Bill No. 02-128

TITLE: **CHANGE OF ZONE NO. 3368**, from R-3 Residential to O-3 Office Park, requested by J. Michael Rierden on behalf of Pioneer Woods, L.L.C., on property generally located at the northeast corner of So. 70th Street and Pioneers Blvd.

P.A.S.: **Change of Zone #3368** **DATE:** June 12, 2002
 Use Permit #144 - Pioneer Woods 1st Addition
****As Revised by Planning Commission: 7/10/02****

UP 144 Pedestrian Exhibit

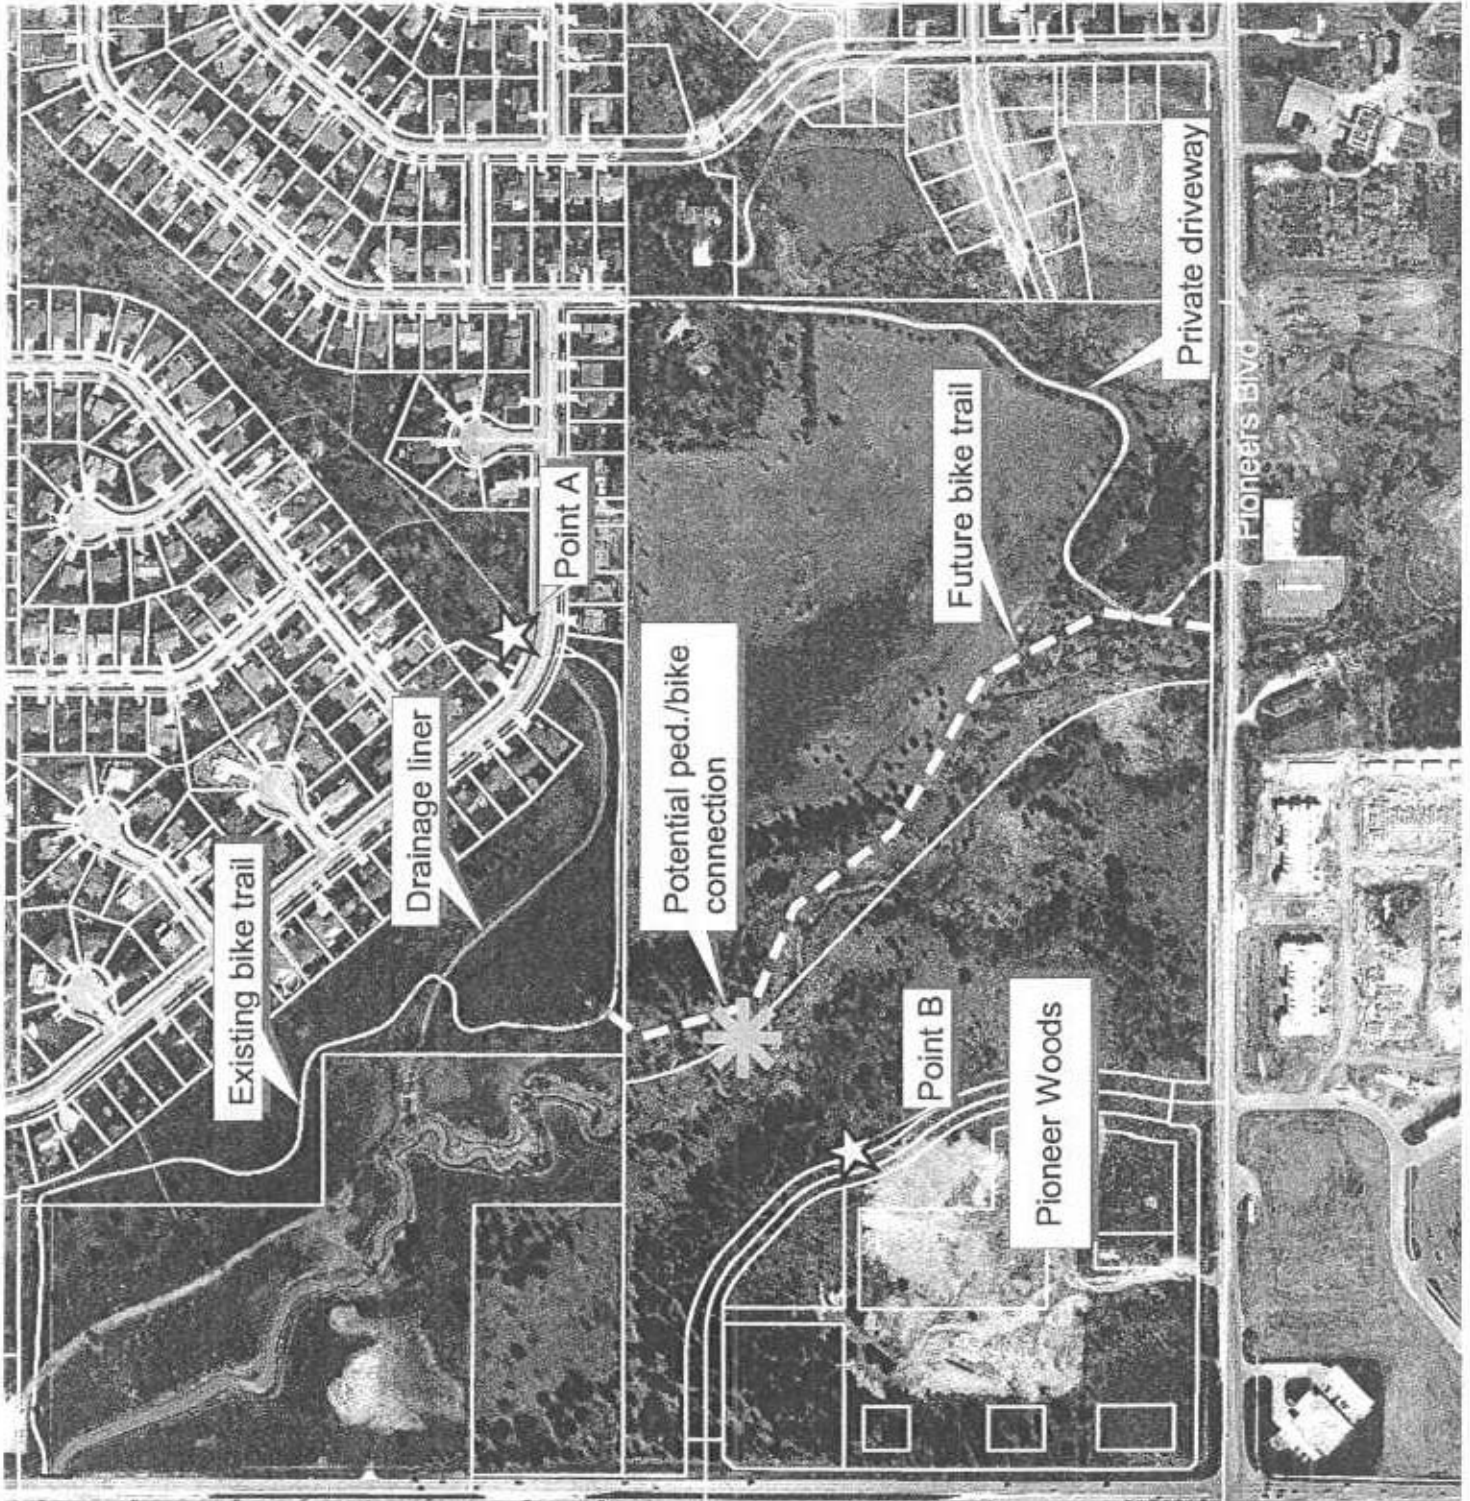
With connection - 1,700 ft

Without connection - 5,900 ft.

If this development does not provide a pedestrian connection over Antelope Creek, the pedestrian network serving this shopping center is poor.
